**SOIL/SITE EVALUATION  
 for ON-SITE WASTEWATER SYSTEM**

Lot 4/9  
 Stone Cross  
 1" = 30'

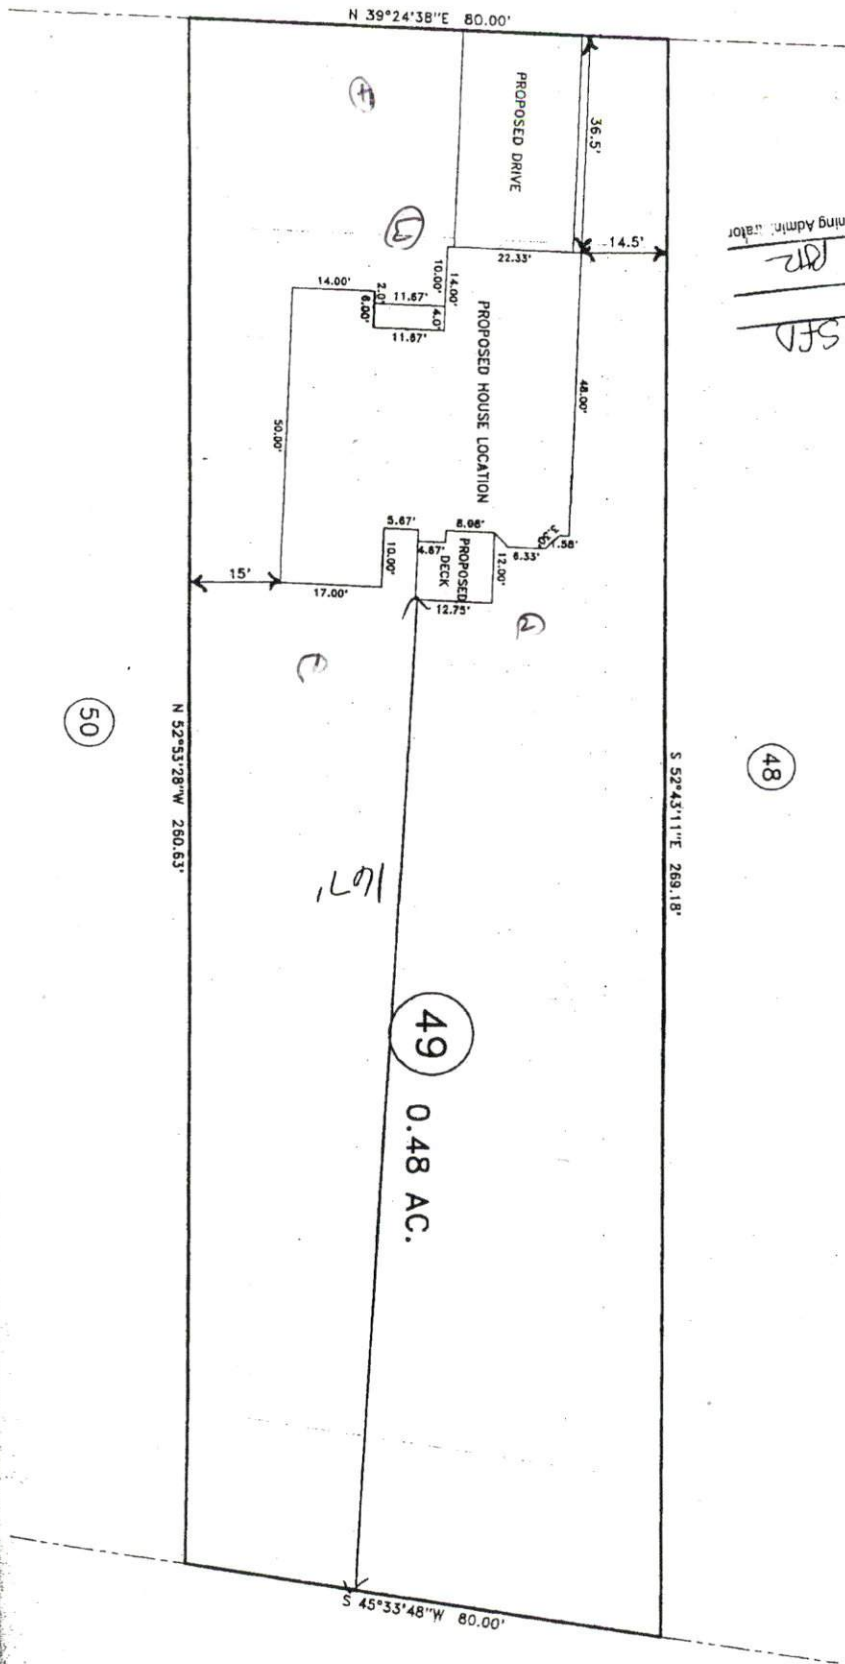
- MOVE HOUSE 90' FROM FRONT PL
- 20' DRIVE ON RIGHT SIDE (GARAGE HOUSE)
- IF FRONT ENTRANCE GARAGE HOUSE MUST BE MOVED FORWARD TO ACCOMMODATE DRIVE

ADD 2 LINGS  
 REDUCE LENGTH

Accepted  
 Dual Field System with
